## **GREER AND STEINER SUBDIVISION**

APPLICATION NUMBER 10 DATE December 7, 2006  
APPLICANT Greer and Steiner Subdivision  
REQUEST Subdivision

# DETAIL SITE PLAN

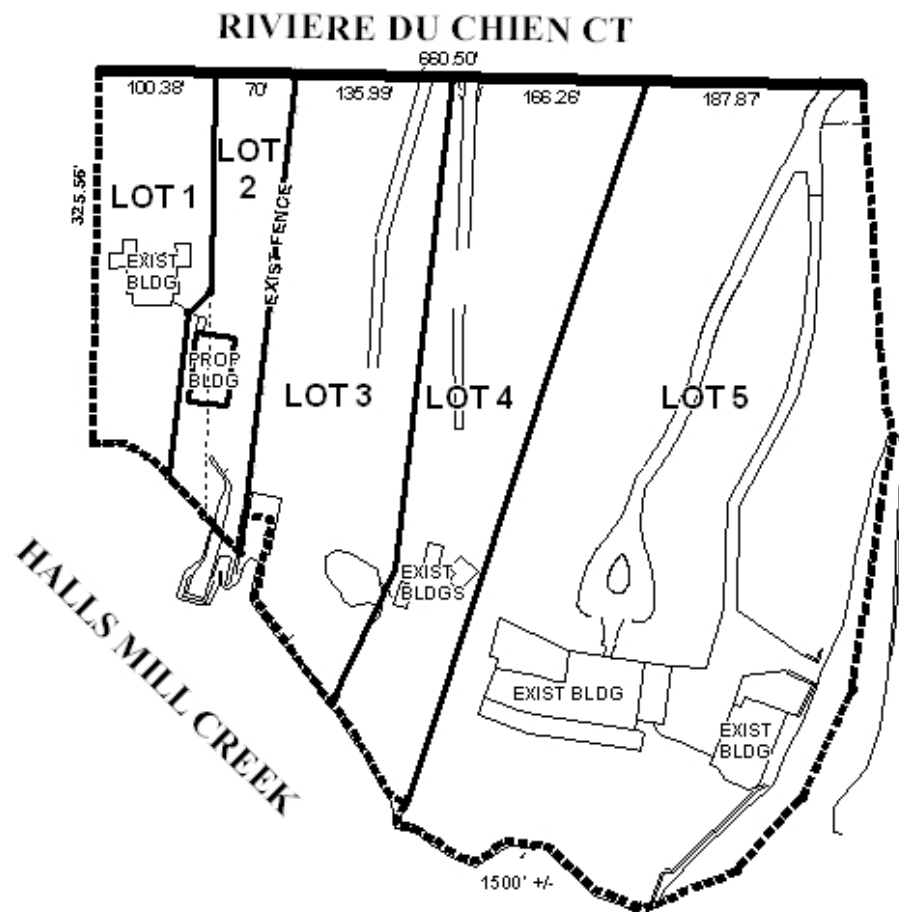
The plat illustrates the proposed 7.6 acre  $\pm$ , 5 lot subdivision which is located on the South side of Riviere du Chien Court, 125'  $\pm$  West of Riviere du Chien Road, and is in Council District 4. The applicant states that the subdivision is served by both public water and sanitary sewer.

The site fronts onto Riviere du Chien Court, a minor street that lacks curb and gutter, and that has a 30-foot right-of-way. The minimum right-of-way width for a minor street lacking curb and gutter is 60 feet, or 30 feet in each direction as measured from the centerline of the roadway. Since the existing right-of-way does not meet the recommended minimum width for a minor street lacking curb and gutter, the dedication of right-of-way sufficient to provide 30 feet, as measured from the centerline of Riviere du Chien Court should be required. Additionally, the 25-foot minimum building setback line, which is not depicted on the plat, should be adjusted to reflect the dedication, and should be depicted on the plat.

As Riviere du Chien Court is a minor street lacking adequate right-of-way, and as the pavement width of the street does not meet City standards, access management is a concern. A note should be placed on the final plat, if approved, stating that each lot is limited to one curb-cut onto Riviere du Chien Court, with the size, design and location to be approved by Traffic Engineering and conform to AASHTO standards.

Several accessory structures occur on the site. Any accessory structures that remain on the proposed lots, without a primary residential structure, must be removed prior to the recording of the final plat. Evidence of demolition permits shall be sufficient for the signing of the plat.

The southern portion of the site is bounded by Halls Mill Creek / Dog River, and wetlands and floodplains associated with the waterways may occur on a portion of the site. The presence of wetlands and floodplains indicate that the area may be environmentally sensitive; therefore, the approval of all applicable federal, state and local agencies would be required prior to the issuance of any permits or land disturbance activities. Furthermore, the site's location in a floodplain requires that the flood zones and minimum floor elevation be depicted on the plat.

Based on the preceding, the plat is recommended for Tentative Approval, subject to the following conditions: 1) dedication of right-of-way sufficient to provide 30-feet, as measured from the centerline of Riviere du Chien Court; 2) depiction of the 25-foot minimum building setback line to reflect the dedication; 3) placement of a note on the plat stating that each lot is limited to one curb-cut onto Riviere du Chien Court, with the size, design and location to be approved by Traffic Engineering, and comply with AASHTO standards; 4) labeling of each lot with its size in square feet, or provision of a table on the plat with the same information; 5) provision of evidence of demolition permits for accessory structures on lots that do not contain a primary residence prior to the signing of the final plat; 6) placement of a note on the plat stating that approval of all applicable federal, state and local agencies is required prior to the issuance of any permits or land disturbance activities; 7) compliance with Engineering comments (*The applicant is responsible for verifying if the site contains wetlands. The site can be checked against the National Wetlands Inventory on the COM web site Environmental Viewer. If the site is included on the NWI, it is the applicant's responsibility to confirm or deny the existence of regulatory wetlands. If wetlands are present, no fill allowed without a Corps of Engineers permit. Show Minimum Finished Floor Elevation on each lot on the plat. The base flood elevation should be at 10' in the AE zone at this location. Must comply with all storm water and flood control ordinances. Any work performed in the right of way will require a right of way permit.*); and 8) full compliance with all other municipal codes and ordinances.
